ADDENDUM NO. 1

TO THE HVAC Improvements Project AT THE BARAGA COUNTY DHHS BUILDING

ADDENDUM NO. 1 is issued August 10, 2022 to clarify, modify, and/or change the original plans and specifications issued by U.P. Engineers & Architects, Inc. This ADDENDUM NO. 1 is hereby made part of the Contract Documents.

M601

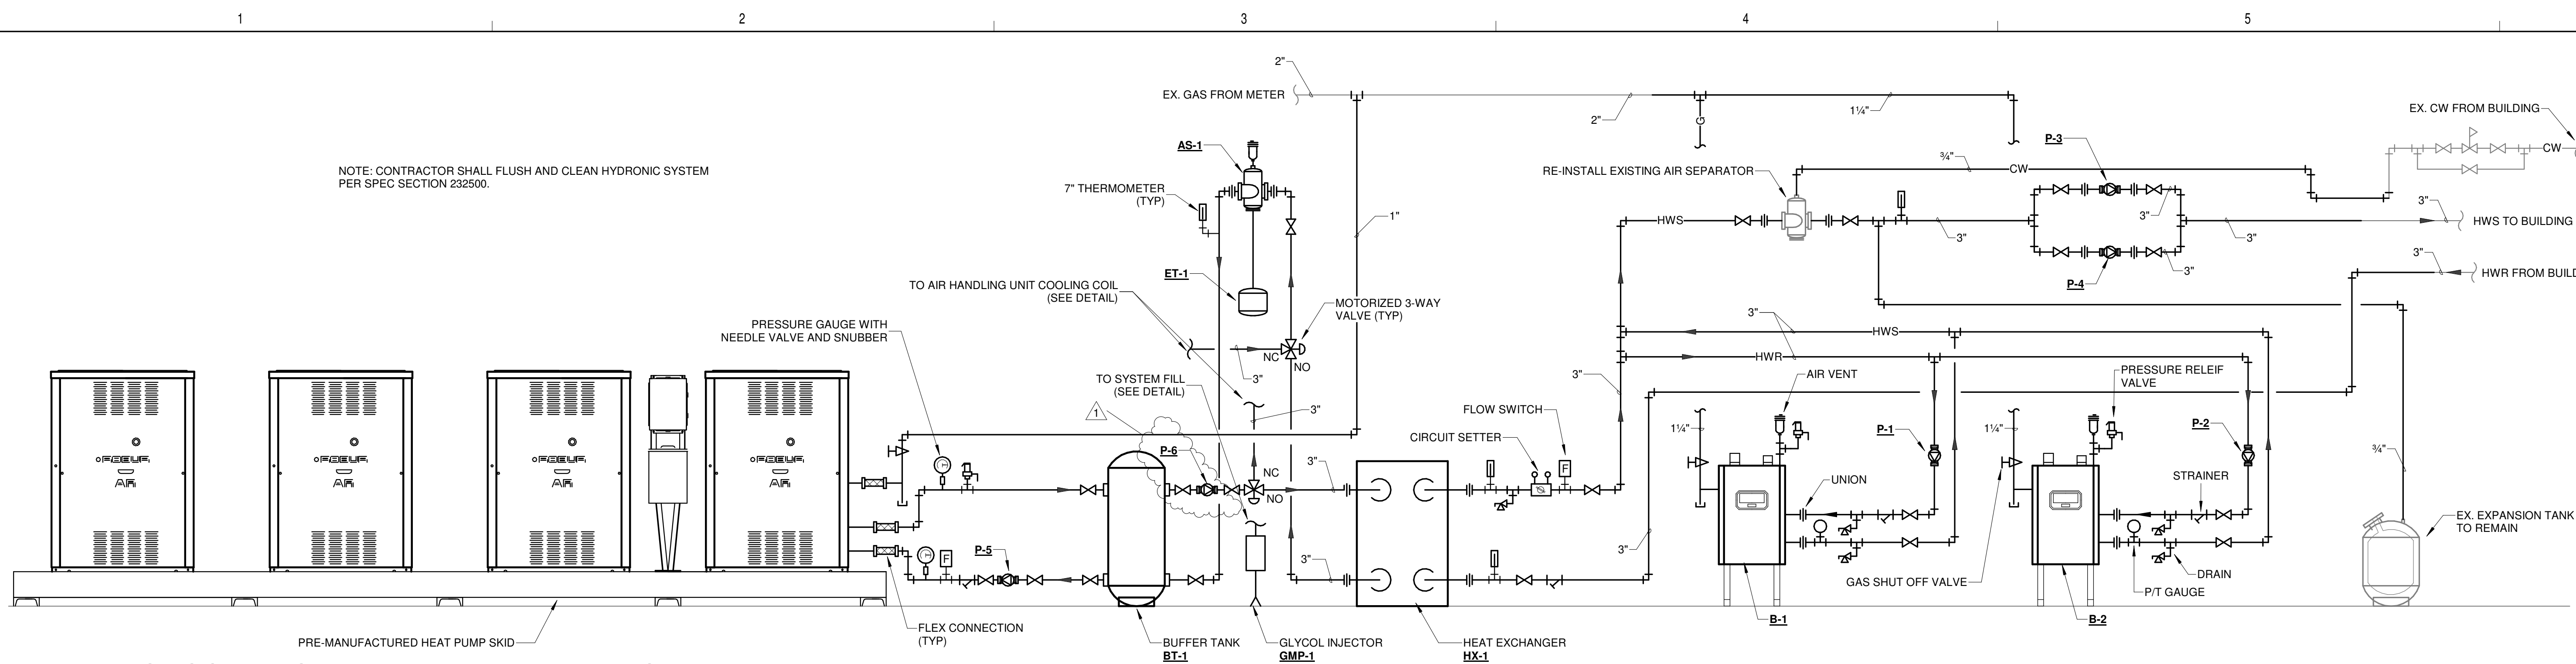
Pump Schedule: Change pump P-5 model number to VR20M, Head (FT) to 20, Suction and discharge size to 2".

Pump Schedule: Add pump P-6: Taco VR25H, 59 GPM, 40 feet of head, 2.5" suction and discharge size.

M101

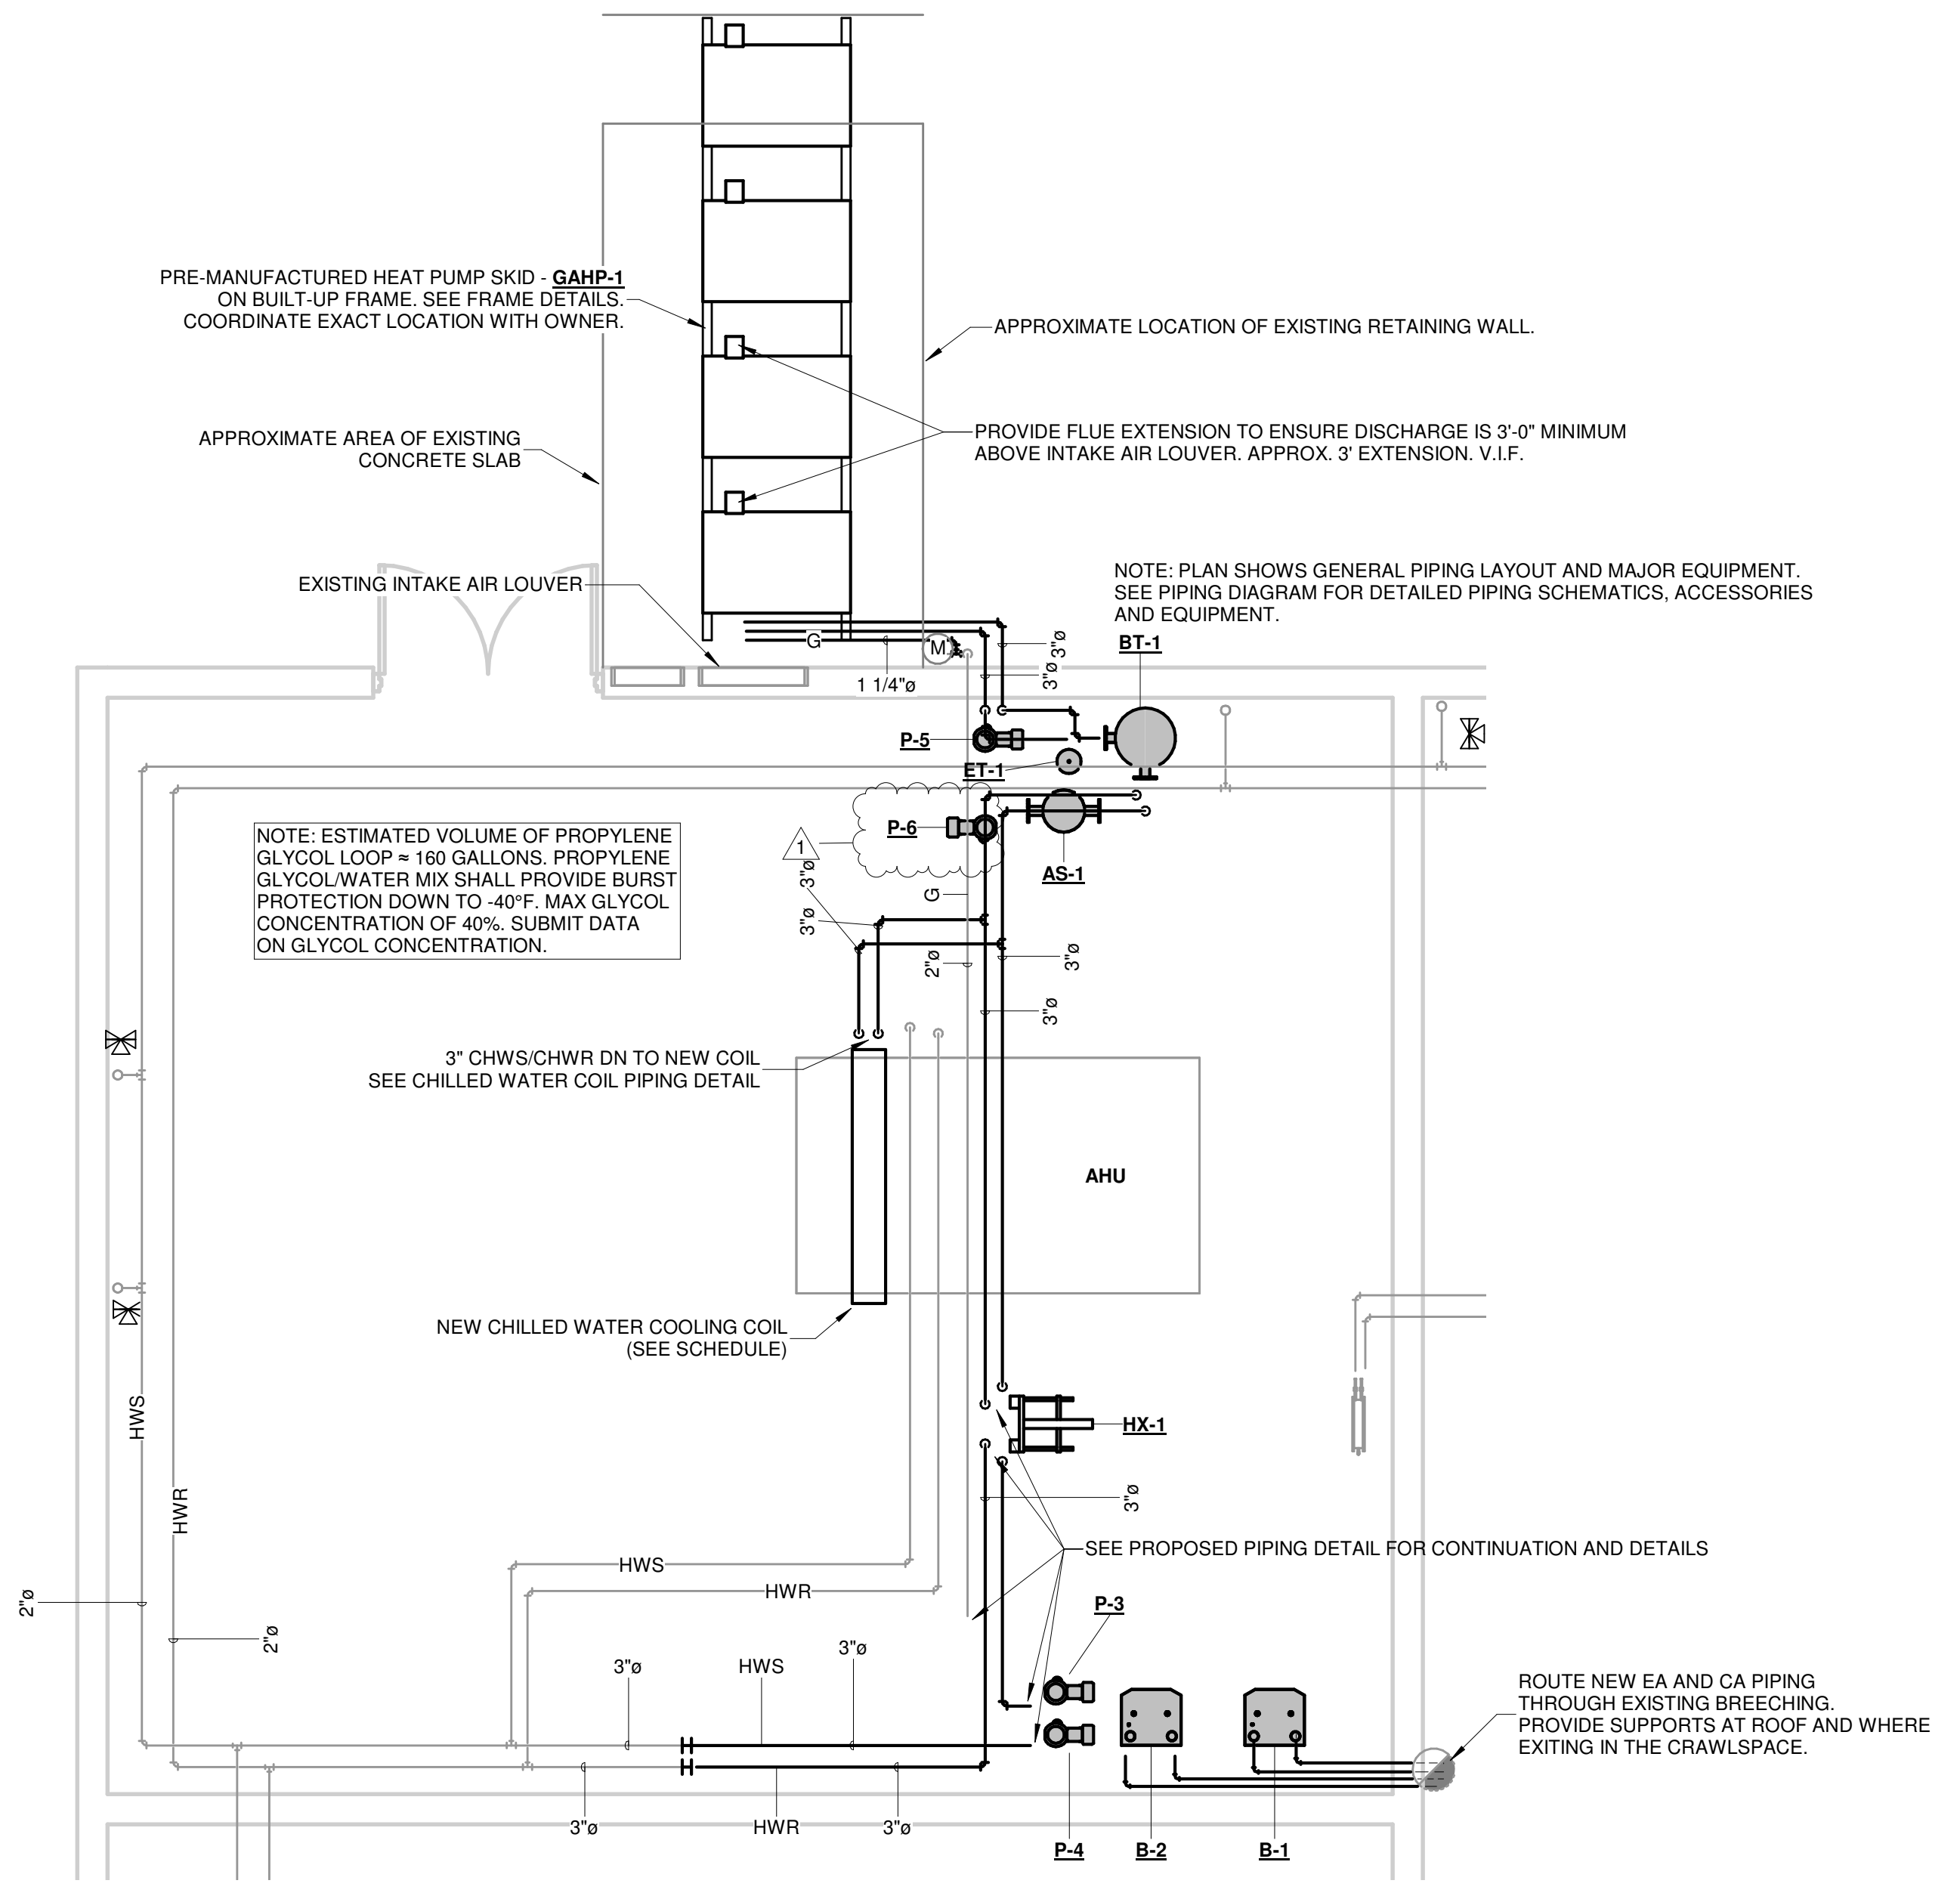
1. Contractor shall provide temporary heat to the existing air handler heating coil via a temporary connection to a boiler. Temporary heat from the boiler can be with one of the new boilers or with a boiler from the contractor. Provide temporary pump(s), expansion tank, combustion air, exhaust air, gas connection, electrical, etc. as necessary. Leave existing heating system in place as long as possible while doing preliminary work. Once the temporary boiler is operating, reconfigure the system as shown on the drawings. Coordinate shut-down of the system with the owner 1-week in advance. Owner shall provide temporary electric heat in offices as needed.
2. Sheet M101: Mechanical Plan Attached
Proposed Boiler/Heat Pump Piping Details: Add pump P-6
Enlarged Basement Proposed Hydronic Plan: Add pump P-6
